ADDENDUM

ADDENDUM #: 03
DATE: February 23, 2026
BID DATE: February 27, 2026, 2:00 PM
SUBMITTED BY: Verde Design Inc.
PROJECT: Lodi High School Athletic Field Improvements
VERDE'S PROJECT NO.: 2502700
FILE NAME AND PATH: Y:\Projects-FO\2025\2502700 - Lodi HS Baseball and Softball Field\Construction Services\Bid Items\20260223_Bid Addendum 03

The changes, clarifications, or modifications to the Lodi High School Athletic Field Improvements Construction Drawings are as follows:

GRADING PLAN - SOFTBALL FIELD

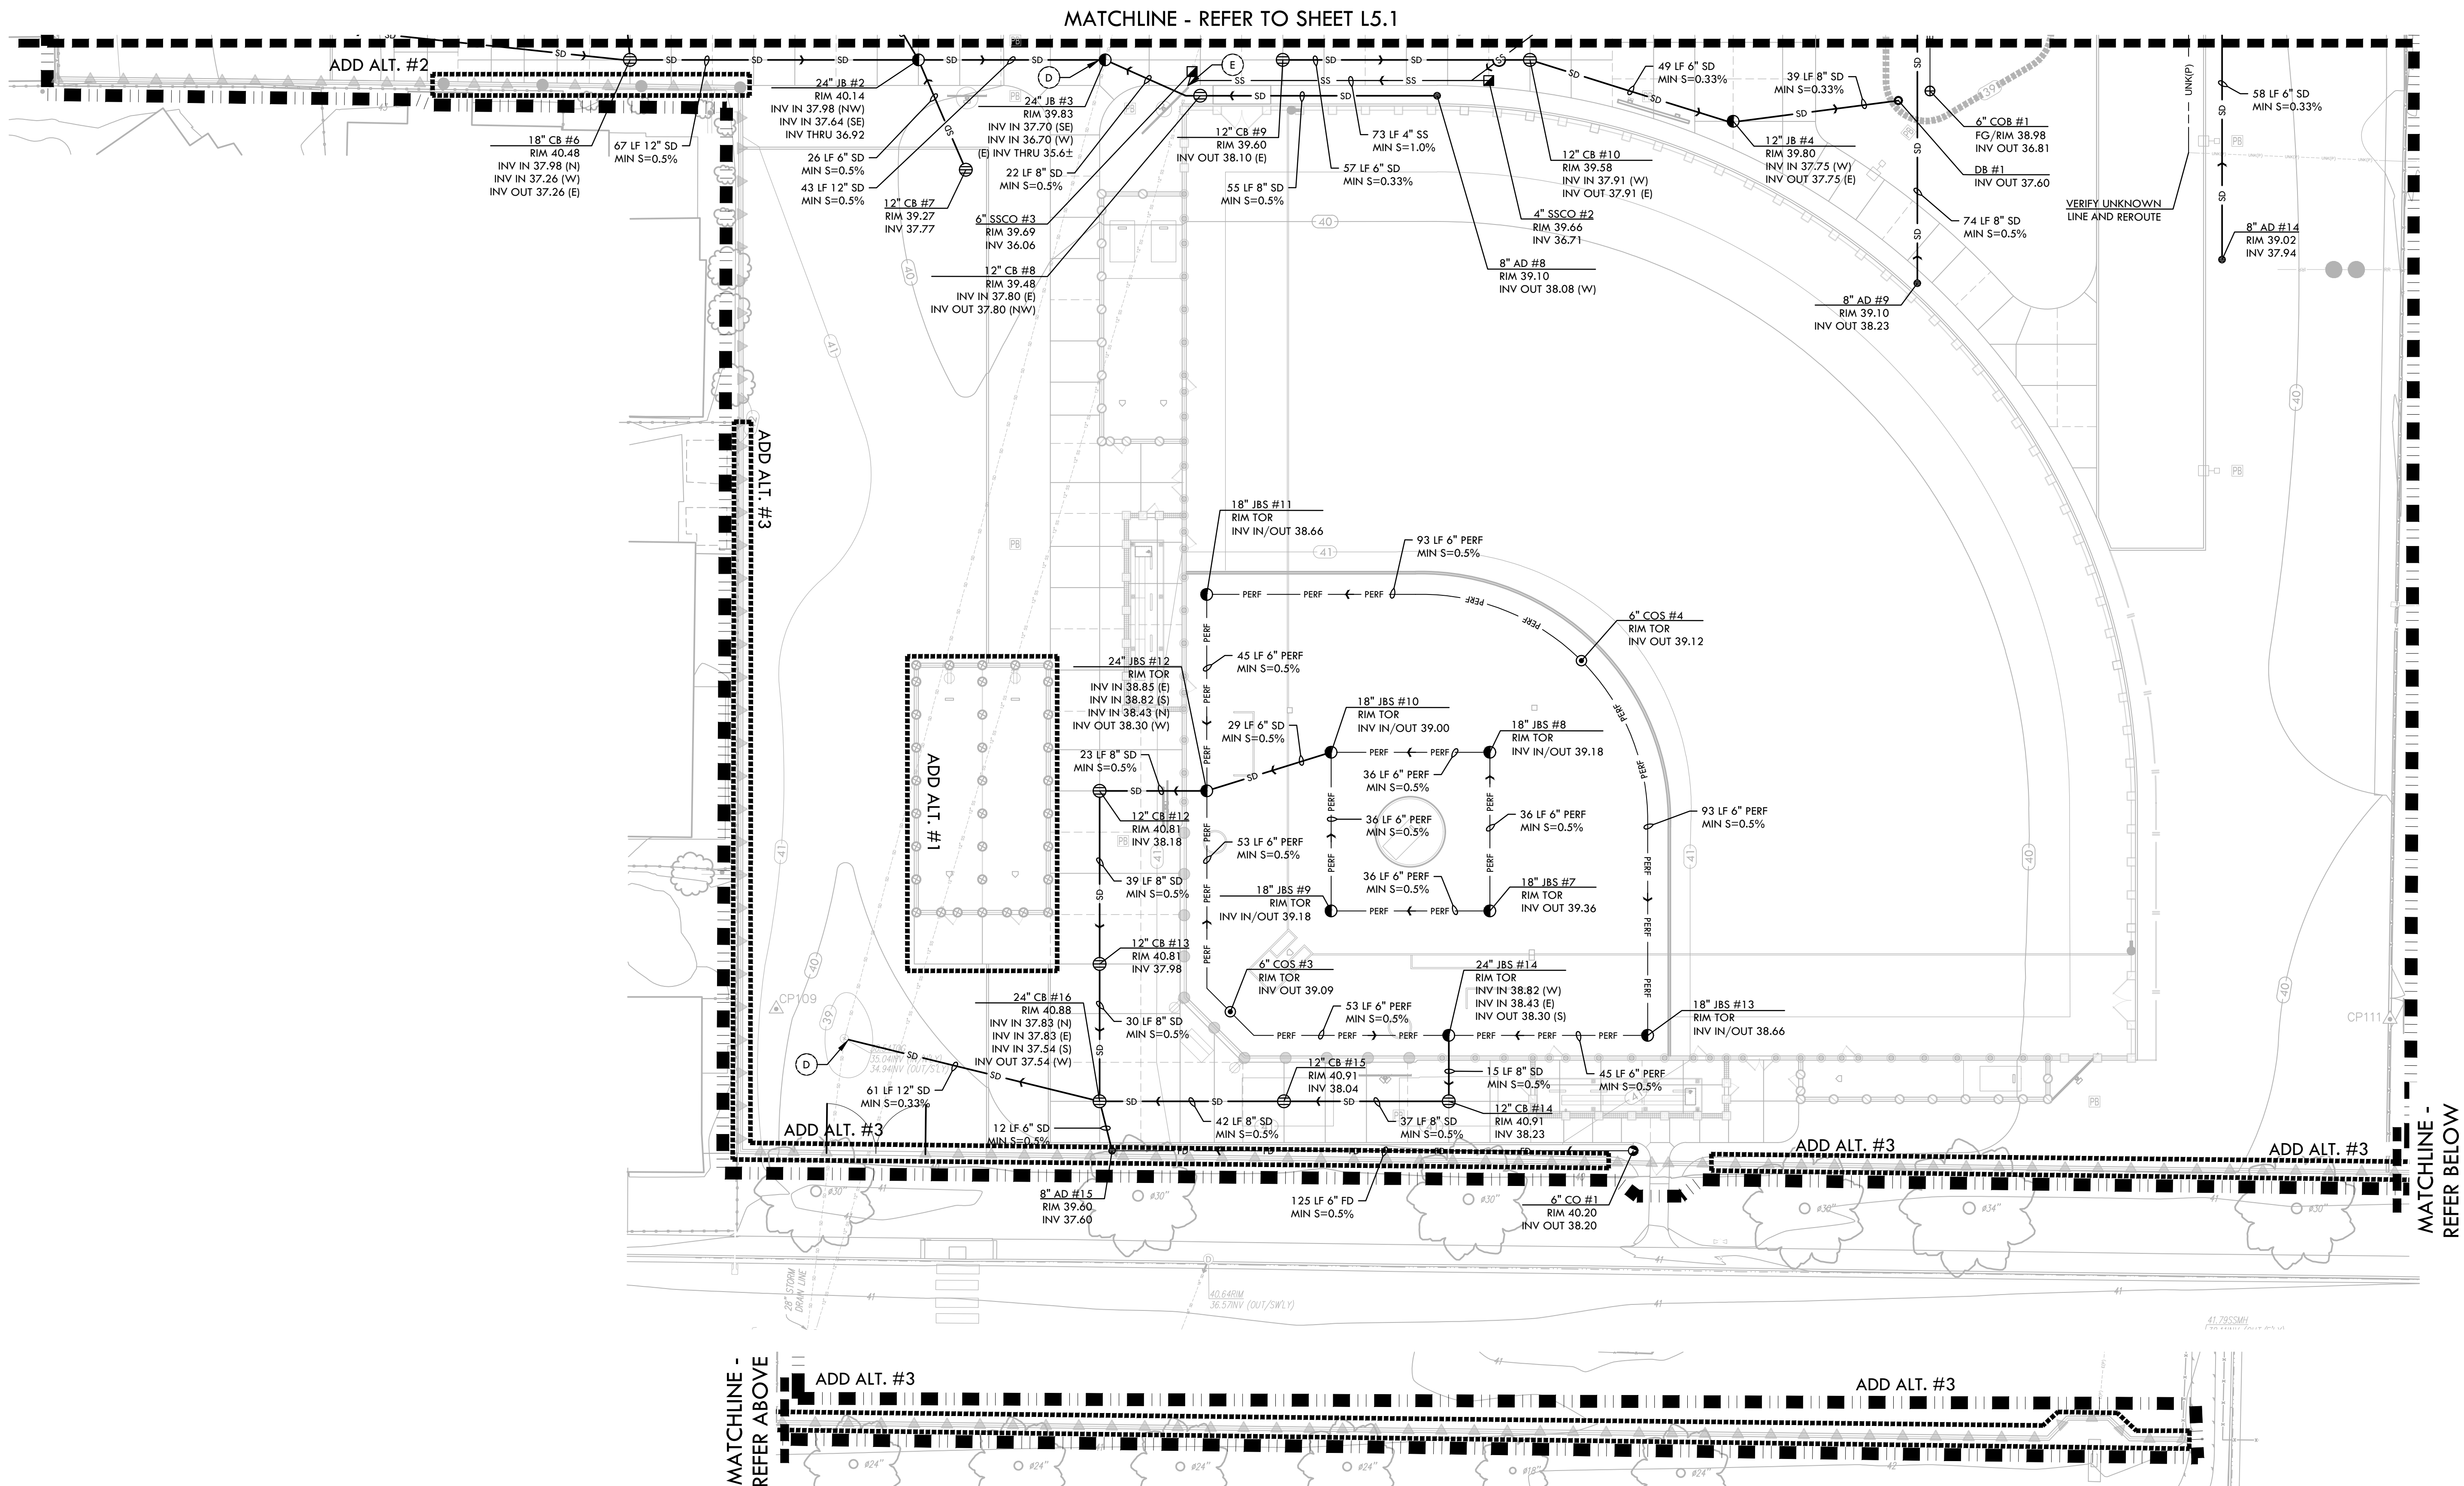
L4.2 – Grading Plan

1. 7' tall x 24' wide double swing gate has been added to the plan set.

DRAWN BY	CHECKED BY
AJ	CS/MB
DATE ISSUED	SCALE
02/23/2026	1"=20'-0"
PROJ. NO.	
2502700	
SHEET NO.	
L7.1

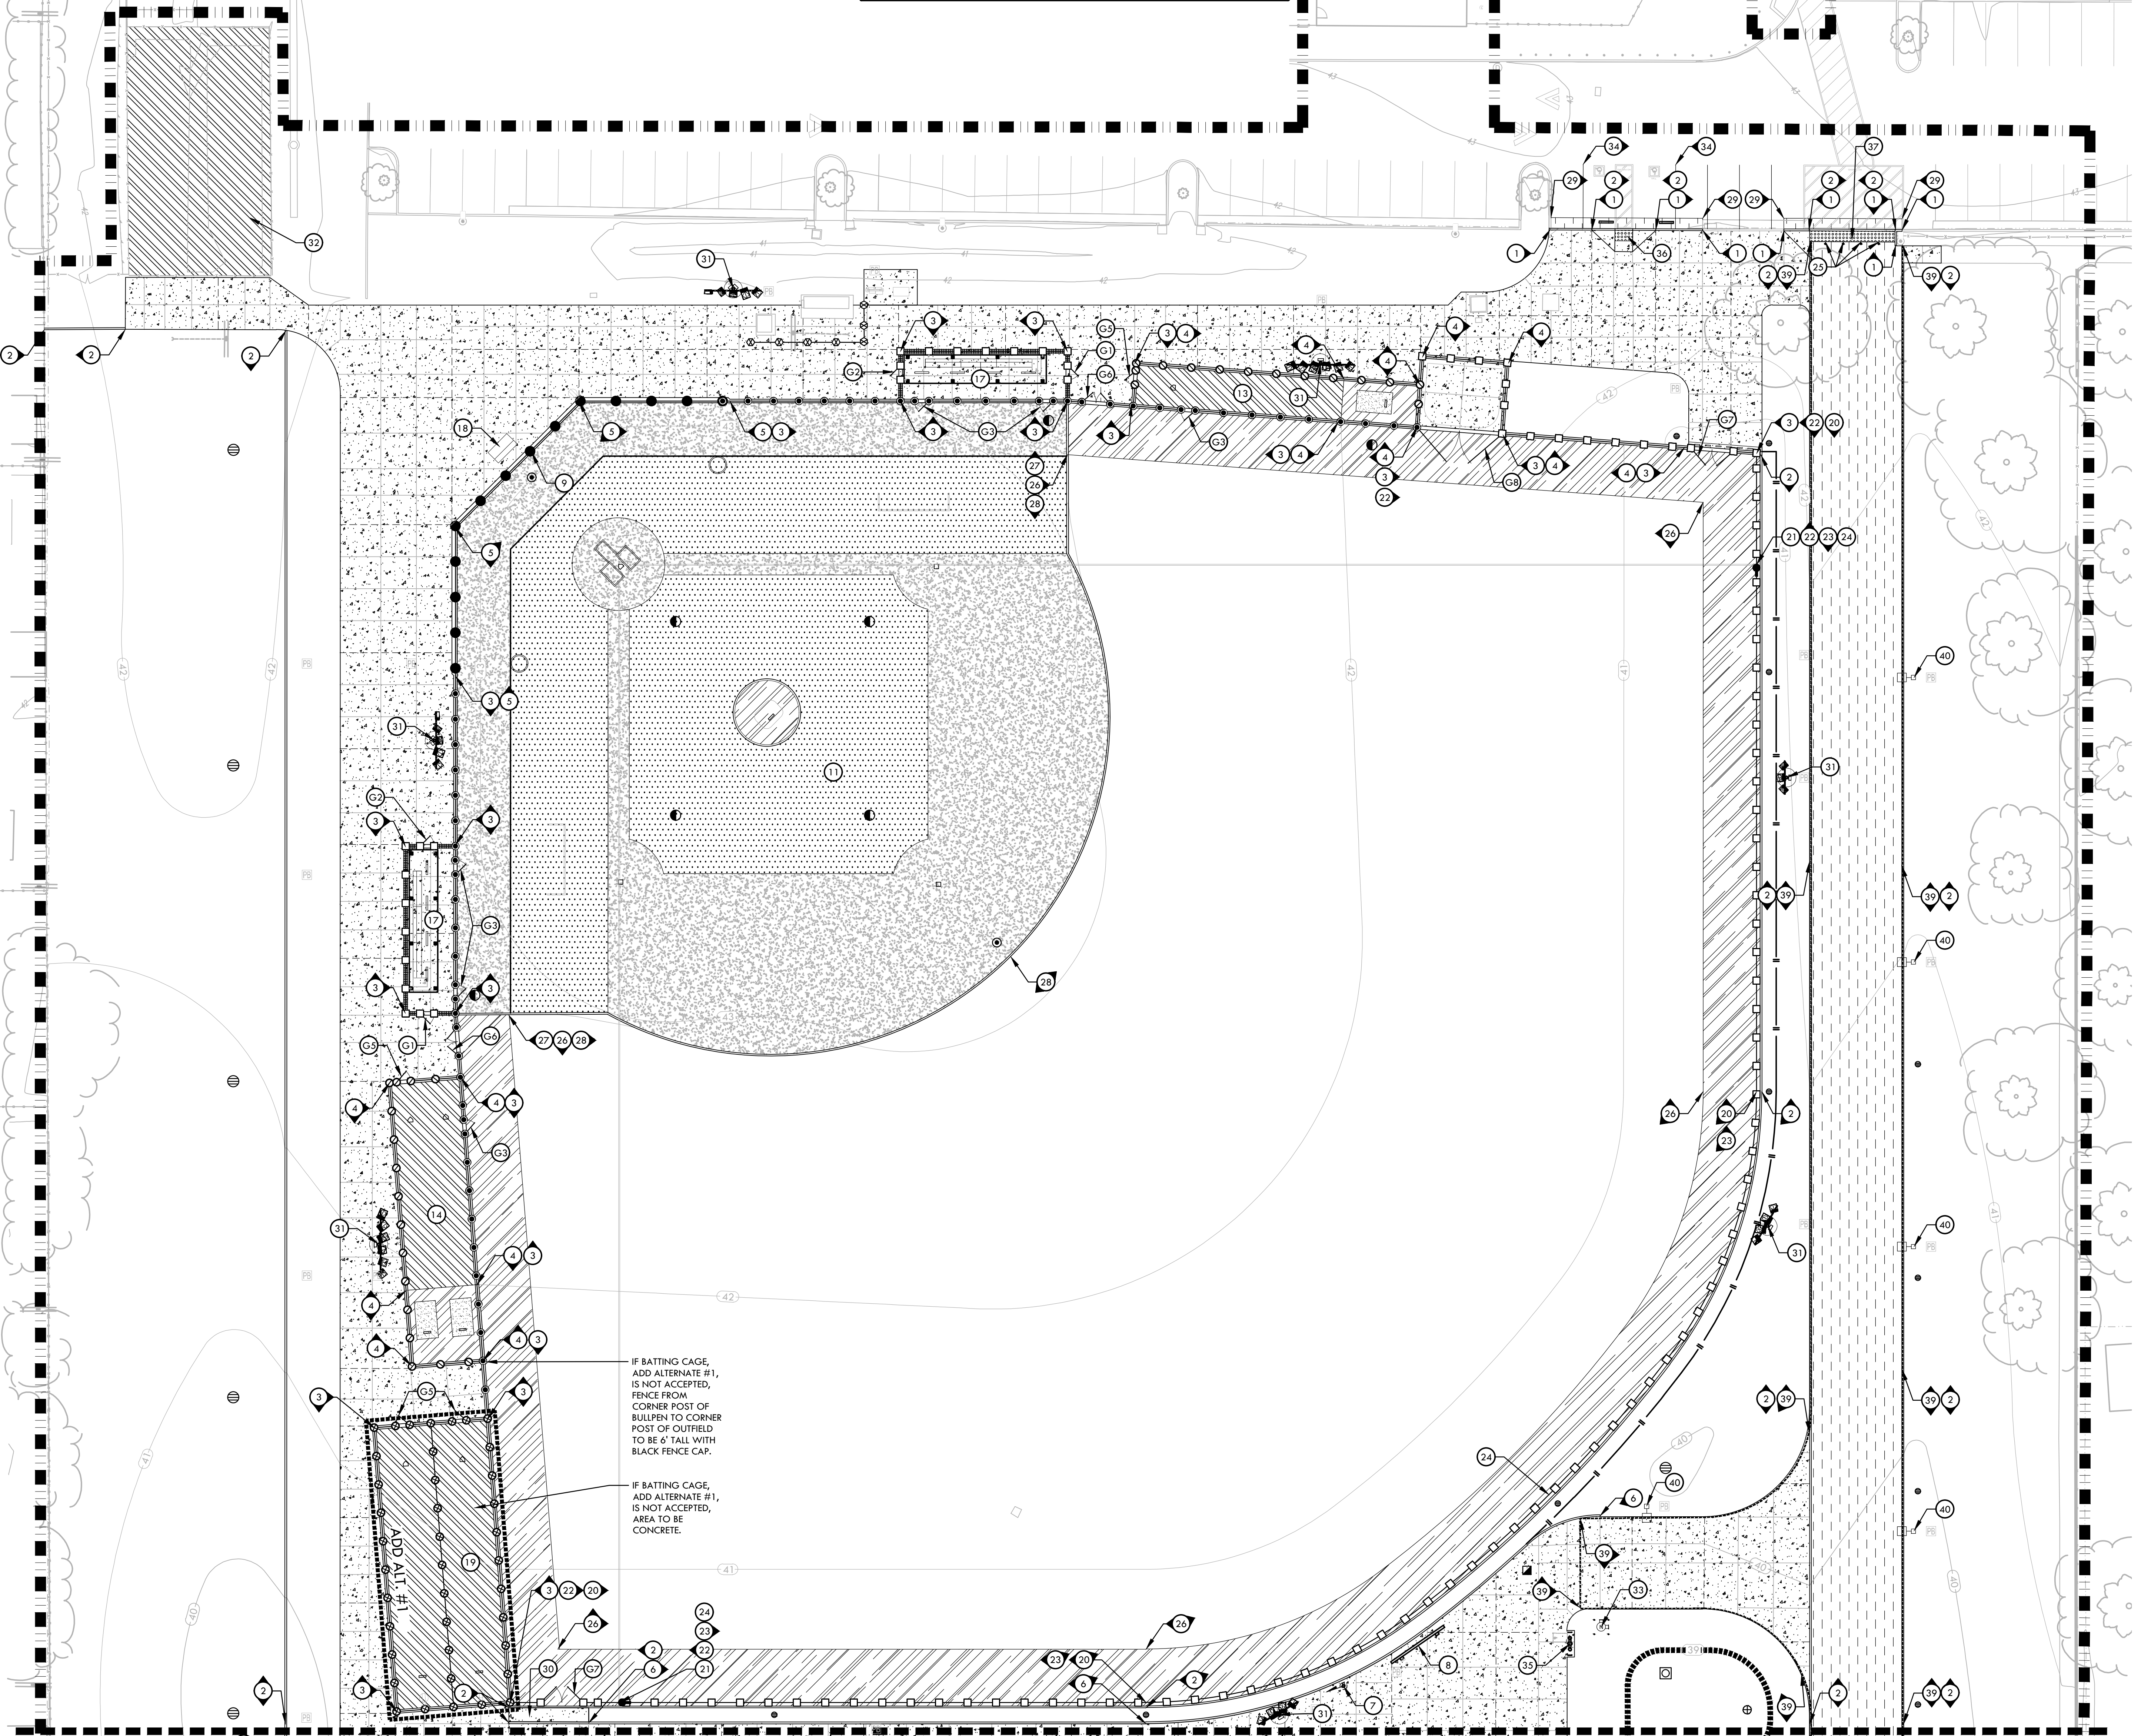
L7.1–L7.2 – Material and Detail Reference Plan

1. Material Legend has been revised to include an additional gate callout – 7' Tall x 24' Wide Double Swing Gate
2. 7' tall x 24' wide double swing gate has been added to the plan set.

L8.2

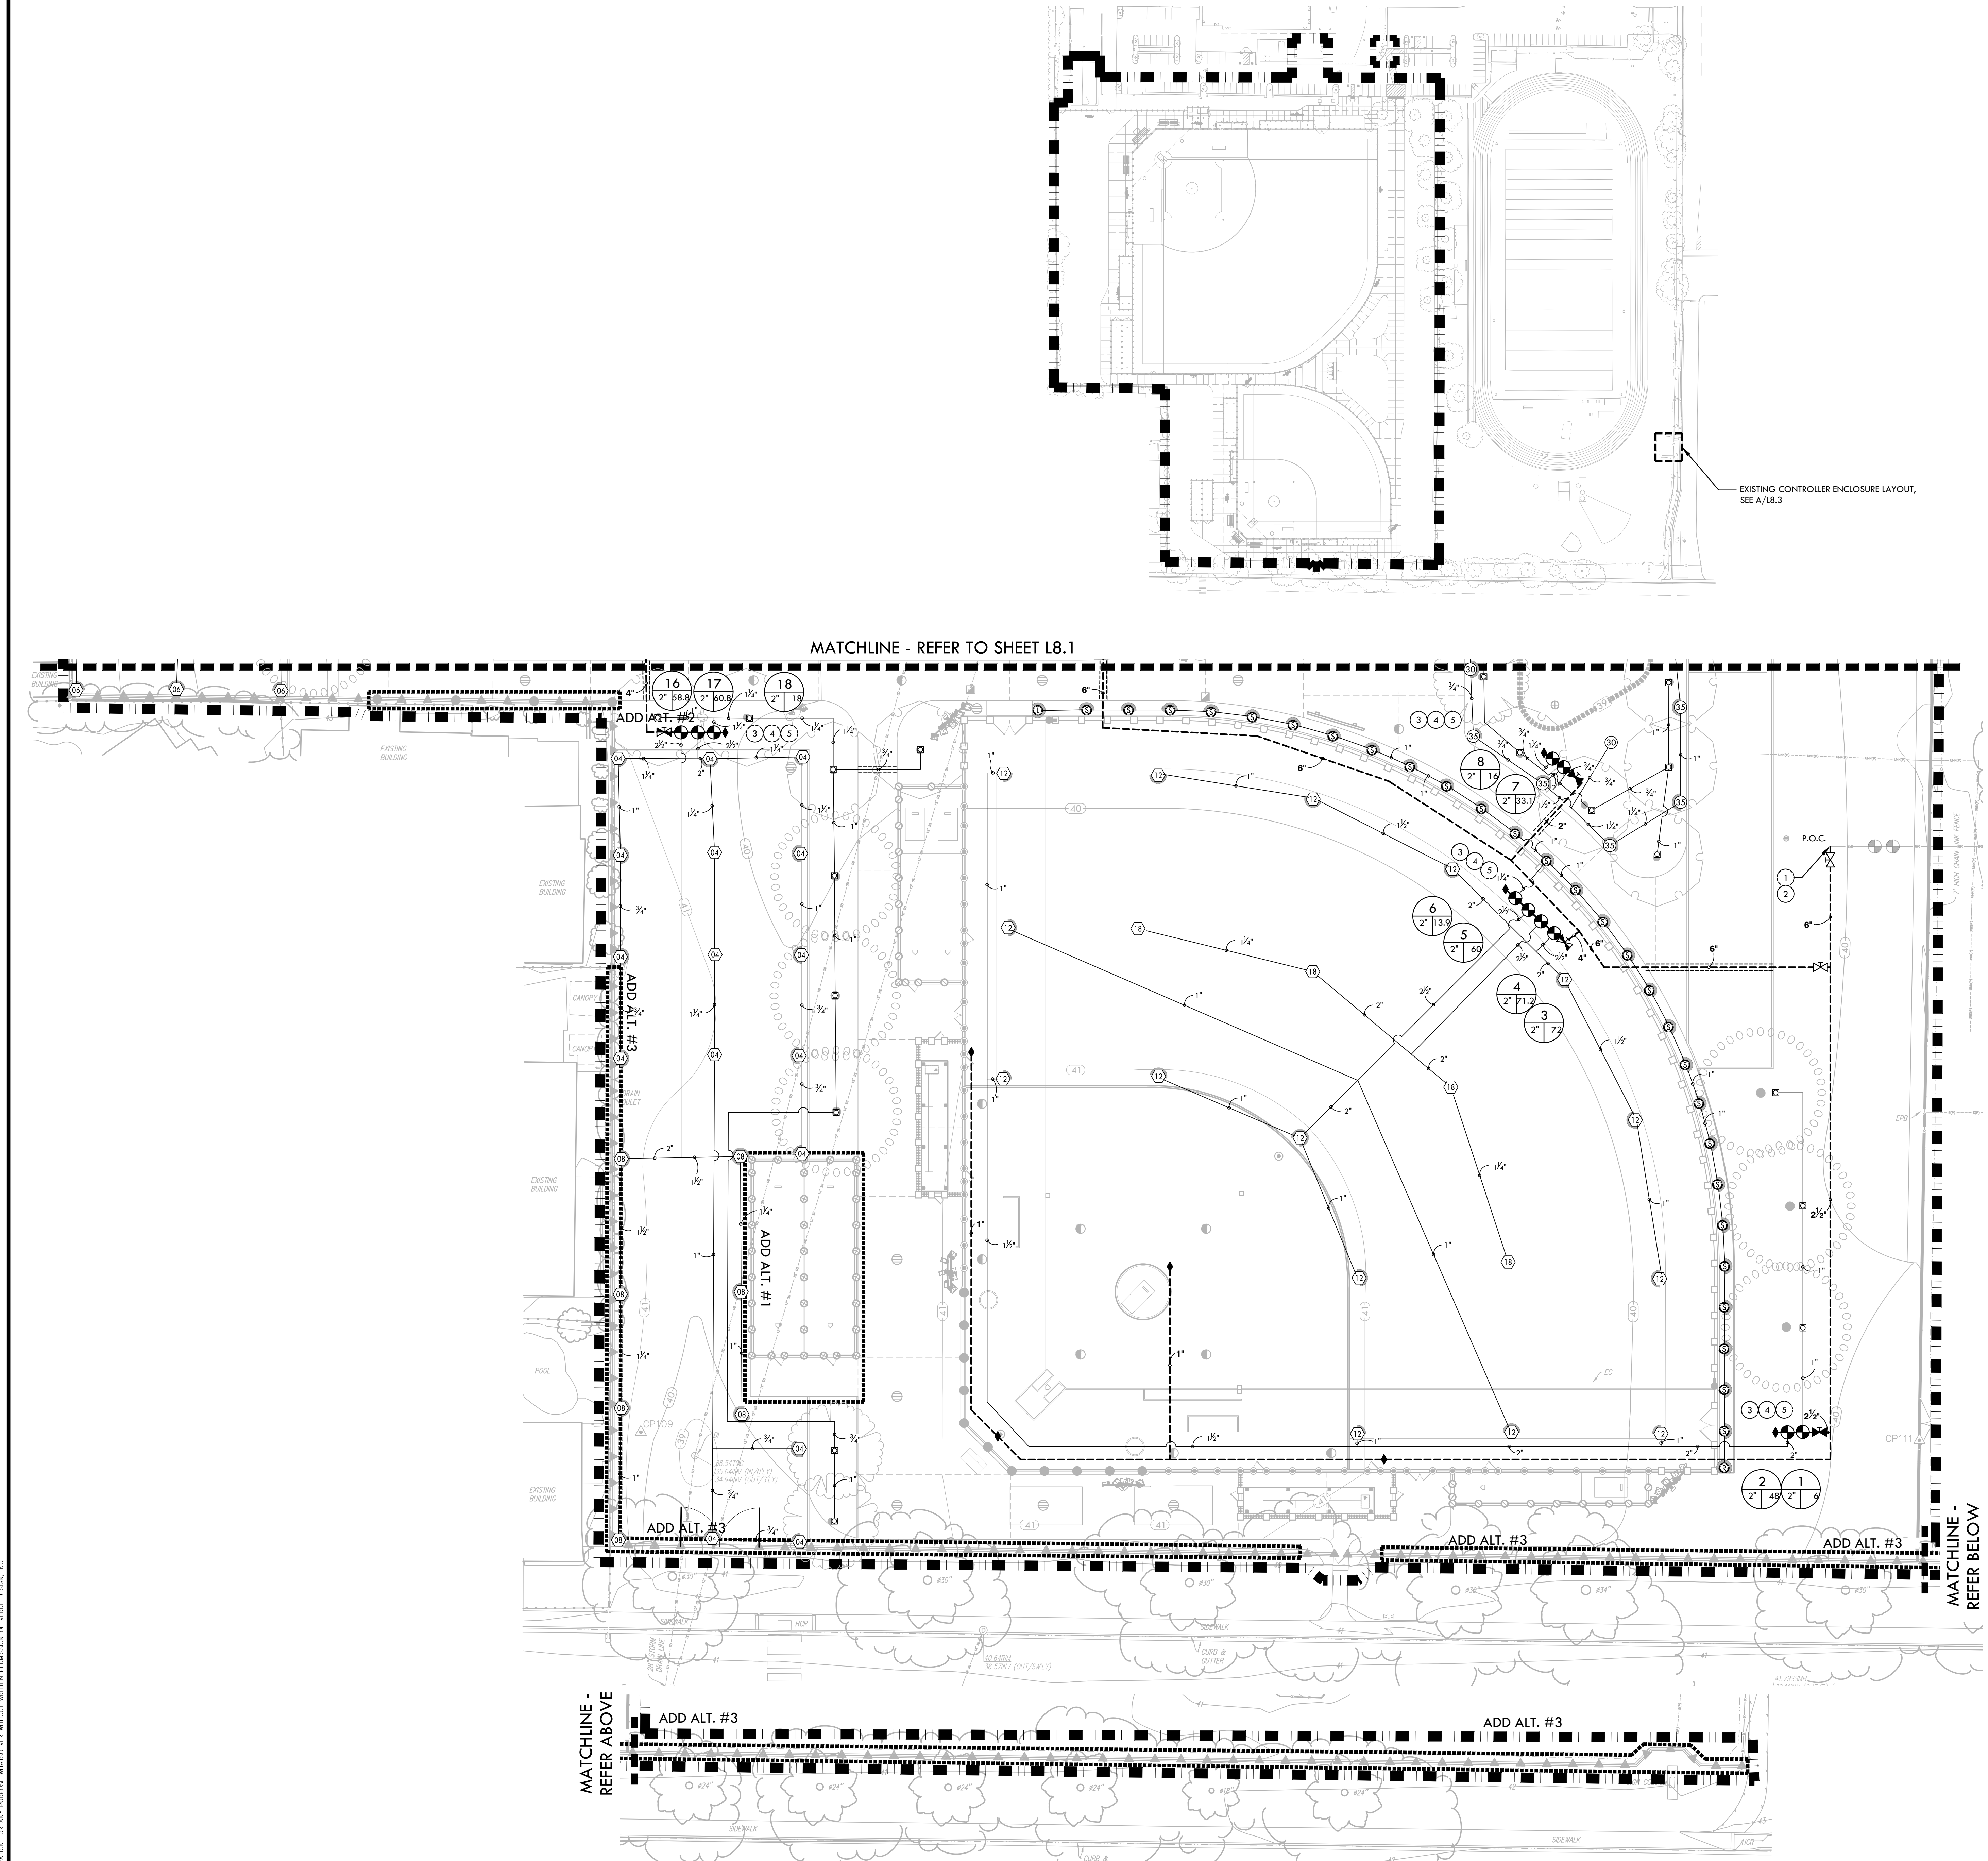
L8.2 Irrigation Plan

1. 7' tall x 24' wide double swing gate has been added to the plan set.
